DC179

Title	Change of Arm set, Joint, Hose connector, Dust nozzle Elimination of O ring 20, O ring 23 Addition of Rivet 7
Model	DSL800, XLS01
Country	All countries
Description	To improve the dust collecting efficiency; • Arm set, Joint, Hose connector and Dust nozzle will be changed. • O ring 20 and O ring 23 will be eliminated. • Rivet 7 will be added.

[1] Arm set (183L76-5)

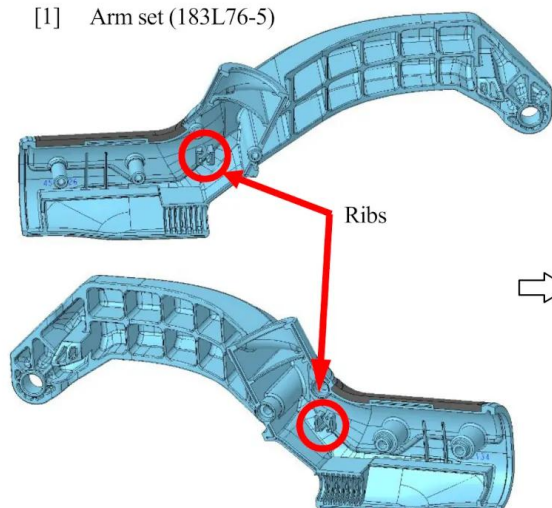
Arm set (183T15-3)

[2] Joint (459222-3)

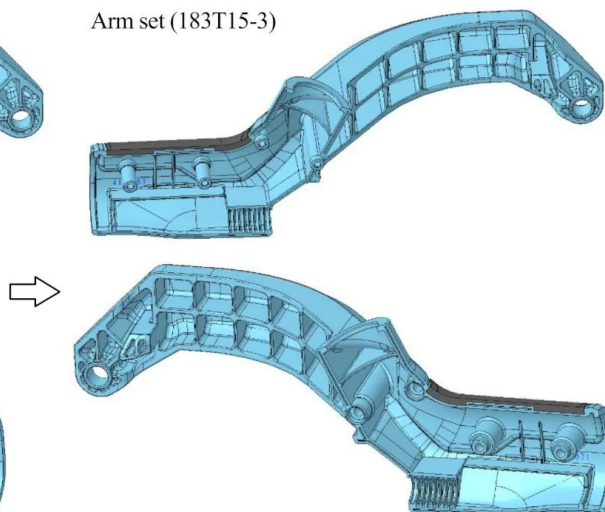
Joint (422617-3)

[3] Hose connector
(459223-1)

Hose connector
(413490-2)

- [4] Elimination of O ring 20 attached to the current Joint
- [5] Elimination of O ring 23 attached to the current Joint

[6] Dust nozzle (459234-6)

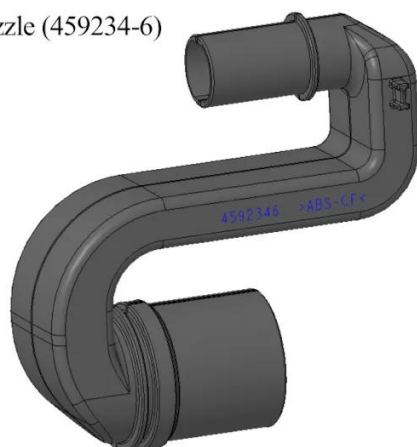
Dust nozzle assy (127672-7)

[7] Addition of Rivet 7 (412987-8)

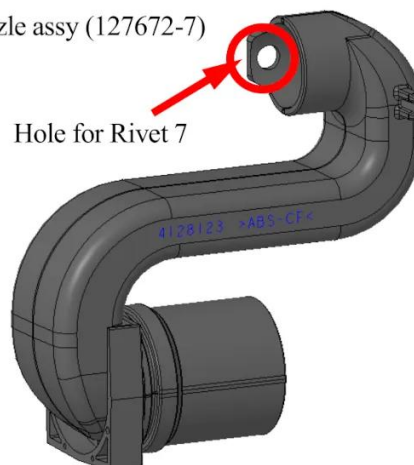
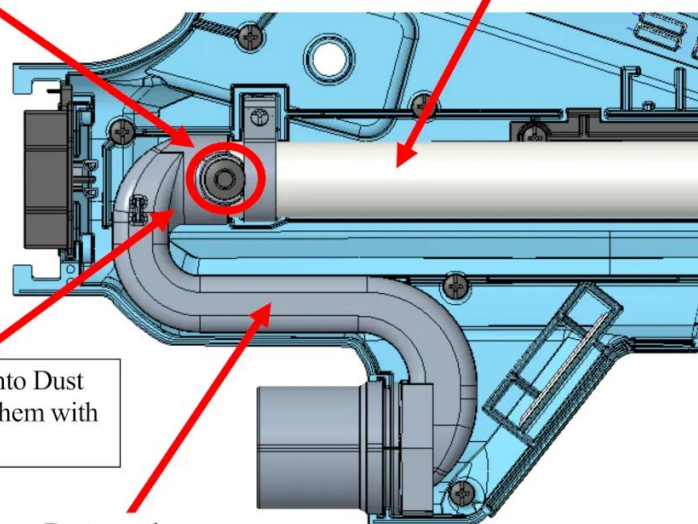
Hole for Rivet 7

Insert Pipe B complete into Dust nozzle assy, then fasten them with Rivet 7 (412987-8).
